nature portfolio

Peer Review File

REVIEWER COMMENTS

**Fig. R1 | Illustration of the MI layer.** It consists of fine copper wires.

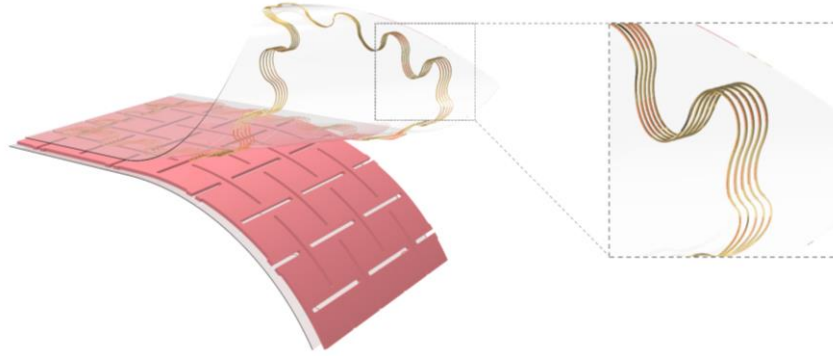
6. How much is the thickness of the MI layer (copper coil)? And how can the author be sure that the serpentine shape of the coil "ensures the flexibility of the device while maintaining its performance"? Have they compared a non-serpentine coil with the one proposed? Or have they made preliminary EM field simulations? They should motivate a little more.

We are very much grateful for the careful attention to detail of the reviewer regarding the question of the MI layer of the device. Thank you for your meticulous observation concerning the MI layer of our device. The coil's serpentine shape is crafted by wiring coil circles concentrically from the center outward, using a serpentine-shaped mold, as depicted in **Figure R1**. While the coil is layered sequentially on the xy-plane, its theoretical thickness should equate to the diameter of the copper coil, which is 67 μm. However, during the fabrication process, the wire tends to overlap, even with efforts to flatten it. We assessed the thickness of several coils (a total of six) used in our device and found an average thickness of 147.33 μm (with individual measurements of 144,

156, 141, 139, 159, and 145 μm). This suggests that, on average, two layers of copper wire overlap during fabrication, leading to an increased overall coil thickness.

Fig. R6 | Accelerated aging test of the device for waterproofness. a, Photos of the device at day 1 and day 7. Scale bar, 0.75 cm**. b,** SPL, Response time, and SNR of the device after different soaking hours.

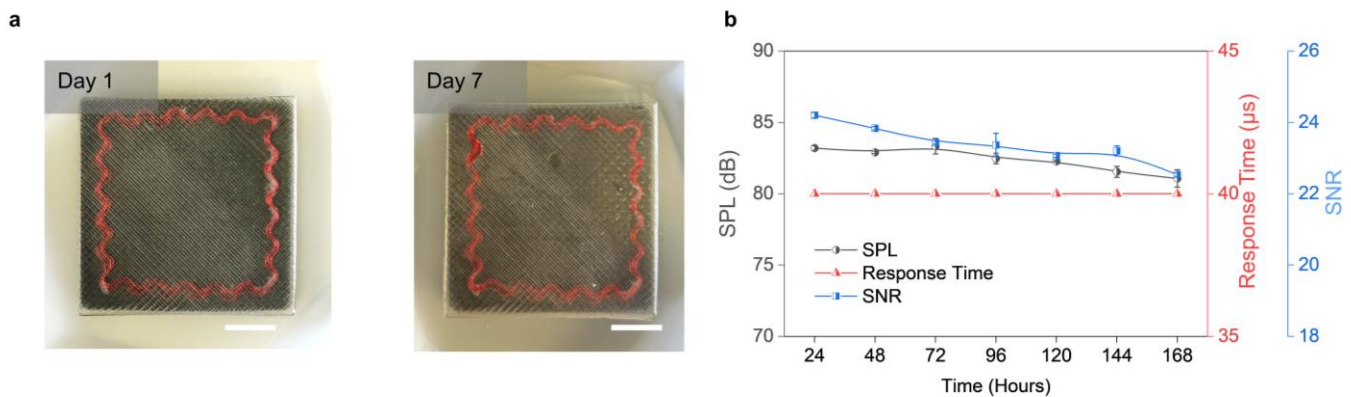
Lines 217-229: the waterproofness of the device was tested but only soaking tests in water until 24hours (at which temperature?). Considering the water permeability of PDMS and the other components of the device at room temperature, 24 hours could not be enough to demonstrate the device reliability. An accelerated aging test at higher temperature could be enlightening.

We would like to extend our sincere appreciation to the reviewer for raising the insightful question regarding the waterproofness of the device. To address this, we undertook additional experiments to rigorously assess its waterproofness. The device was immersed in PBS (Phosphate-buffered saline) and subsequently placed in an oven maintained at a consistent temperature of 65°C. We evaluated the sound pressure level (SPL), response time, and signal to noise ratio (SNR) of the device at 24-hour intervals, continuing up to 168 hours. The findings are presented in **Figure R6**. As depicted in Figure R6a, there is no discernible degradation or disintegration of the device. Furthermore, Figure R6b reveals that the response time, SPL, and SNR of the device remained largely stable, with only minor fluctuations (add data here, e.g., how much percentage…) observed. This consistency underscores the device's robust waterproof attributes, even under the conditions of an accelerated aging test. Corresponding changes have also been made in the supplementary information as supplemental Figure 32.

Fig. R12 | Optical micrograph of the kirigami structure on the MC layer, scale bar, 1mm.

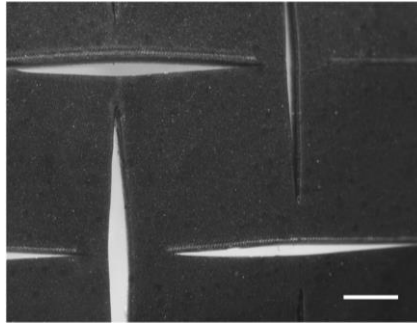
20. How the MC layer is processed with the laser cutter? The authors should show some optical micrographs of the kirigami cuttings in order to give an idea of the sharpness of the cut edges.

5. **Optical Micrographs**: In response to the reviewer's suggestion, we have captured optical micrographs of the kirigami cuttings to provide a clear visualization of the sharpness and precision of the cut edges. These images can be found in **Figure R12**.

Fig. R14 | Magnetization detail illustration of the MC layer. a, the illustration of the magnetization process. **b,** vertical view of the magnetization process of the device in the magnetization chamber.

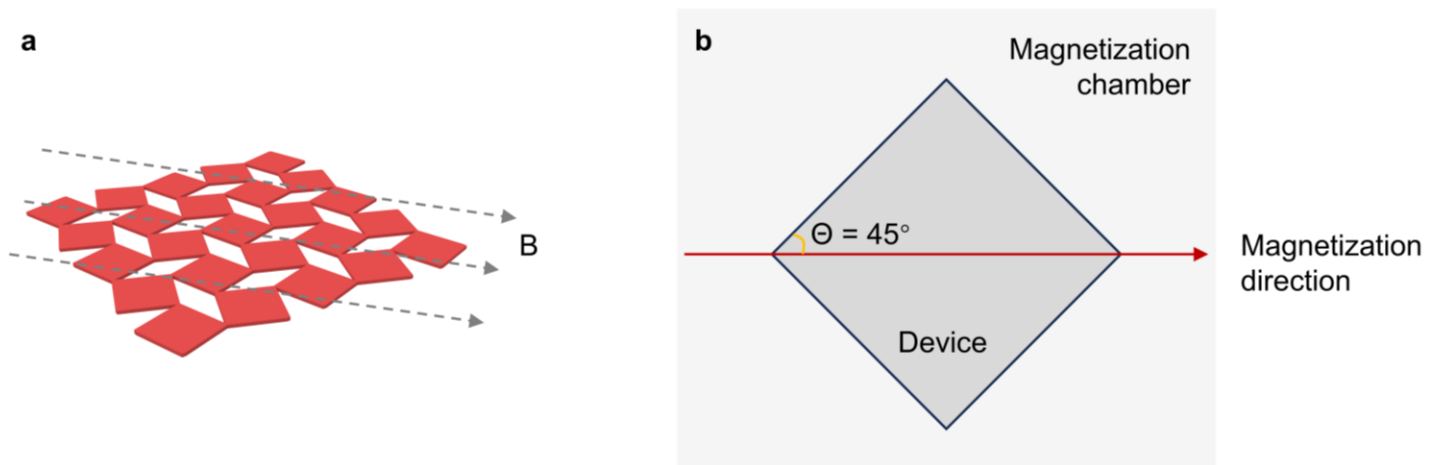
8. In the description that the authors used magnetization impulse field to magnetize the substrate, please provide the direction and magnitude of the field.

We are grateful to the reviewer for highlighting the need for clarity regarding the magnetization process. To address this, the MC layer was magnetized using an impulse magnetizer (IM-10-30, ASC Scientific). Specifically, an induced angle of 45° relative to the magnetization direction was applied with an impulse voltage of 350 V, as illustrated in **Figure R14**a. This angle was chosen to ensure signal generation in both vertical and horizontal directions in-plane. Figure R14b provides a top-down view of the magnetizing process, showing the device positioned in the magnetization chamber such that its diagonal aligns parallel to the magnetization direction. We have incorporated these details into the main text for clarity.

"The cured MC layer was then removed from the mold and magnetized by an impulse magnetizer (IM-10-30, ASC Scientific) with an induced angle of 45°to the magnetization direction at an impulse voltage of 350 V."
